# Origination Form

## Proposed Revisions to a Standard Plans Index

<b>Originator:</b>	Turley, Joshua	<b>Index Number:</b>	700-041
<b>Date:</b>	4/11/2024	<b>Sheet Number(s):</b>	2
<b>E-mail:</b>	Joshua.Turley@dot.state.fl.us	<b>Index Title:</b>	SPAN SIGN STRUCTURE

BASE PLATE CONNECTION

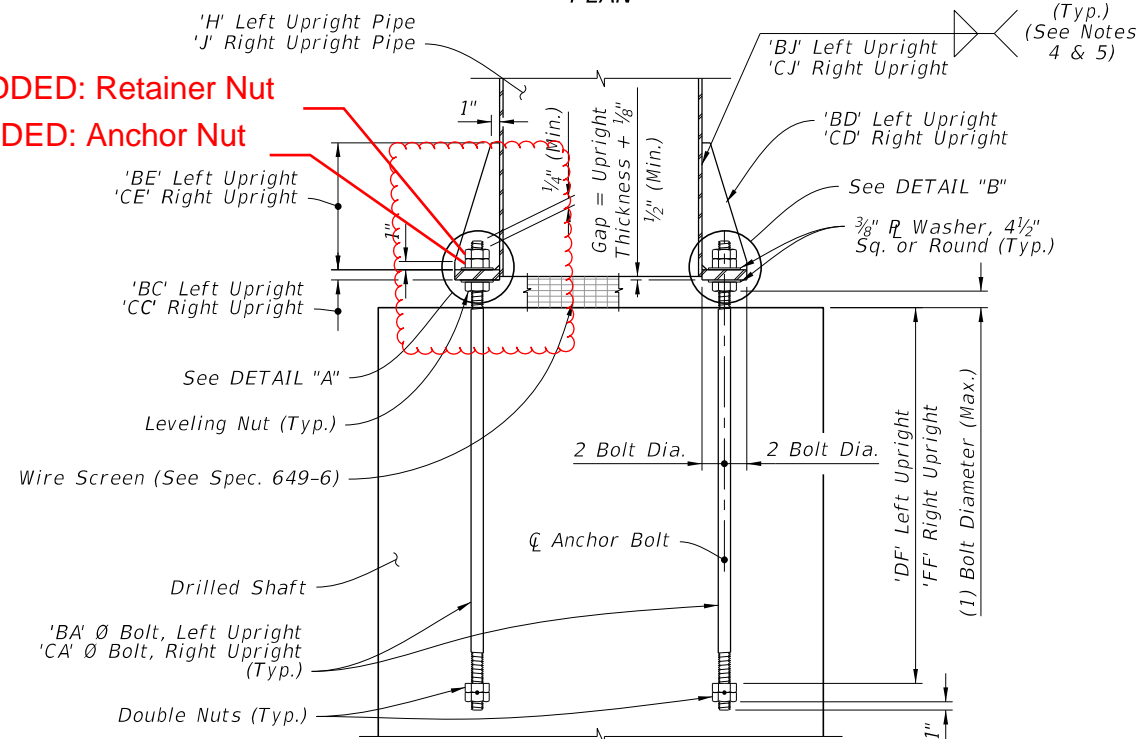
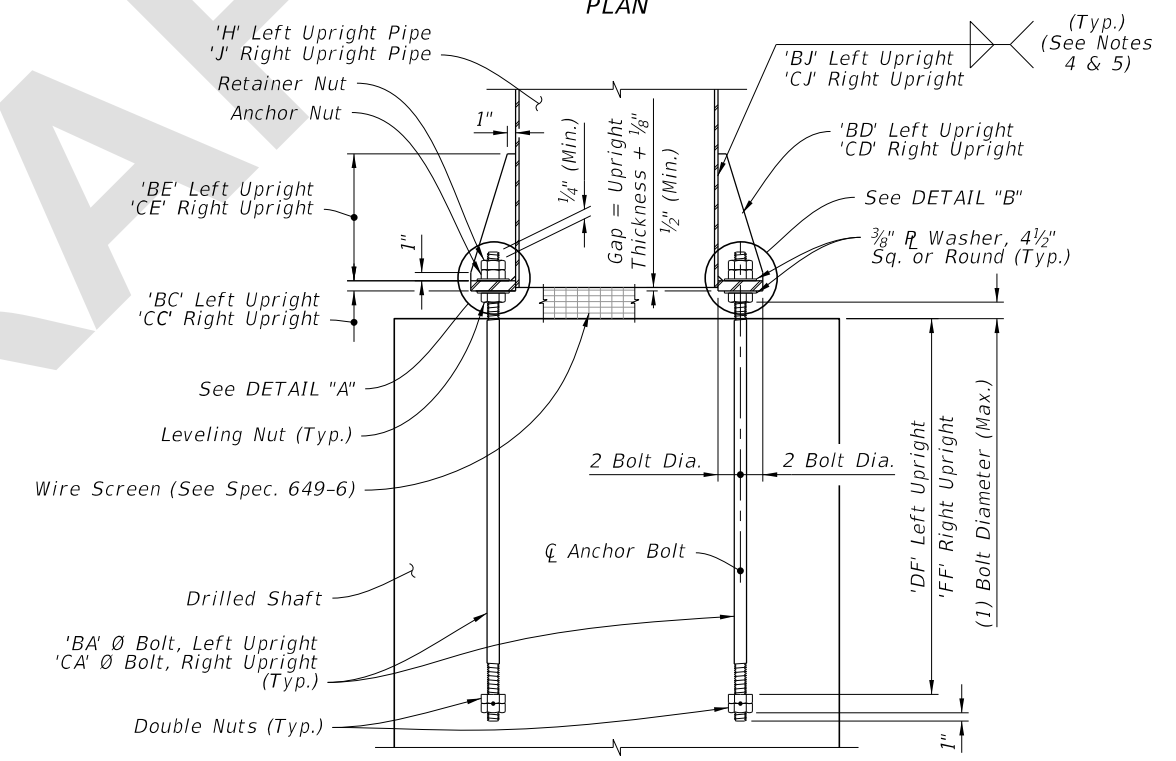
Sheet 2: Added labeling to the Anchor bolt nuts in BASE PLATE CONNECTION - ELEVATION

ADDED: Retainer Nut  
ADDED: Anchor Nut

Labels were added to correspond correctly with upcoming spec change to Spec 649.
